Company	Trenz Electronic GmbH
PCN Number	PCN-20190826
Title	TE0703-06 Under Voltage Protection Change
Subject	Trenz Electronic TE0703 Hardware Change
Issue Date	2019-09-05

affected product
TE0703-06

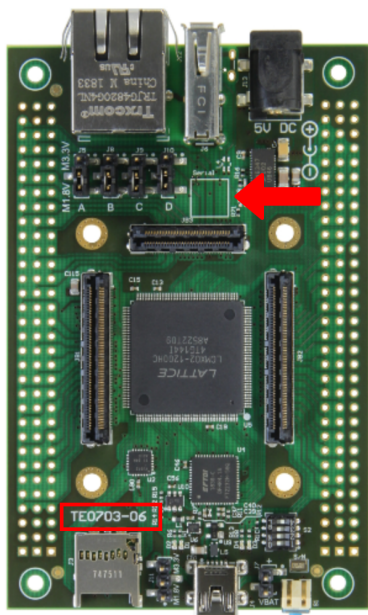
#1 Replaced R31 by 953kOhm and R35 by 147kOhm

Type: BOM change

Reason: Large start up currents led due to adverse conditions (e.g. weak powersupply, long wires, increased contact resistance) to a voltage drop below the under voltage lock out limit of the input protection circuit.

Impact: Under voltage protection limit is decreased to 4.06V, which gives a larger margin for a voltage drop during start up.
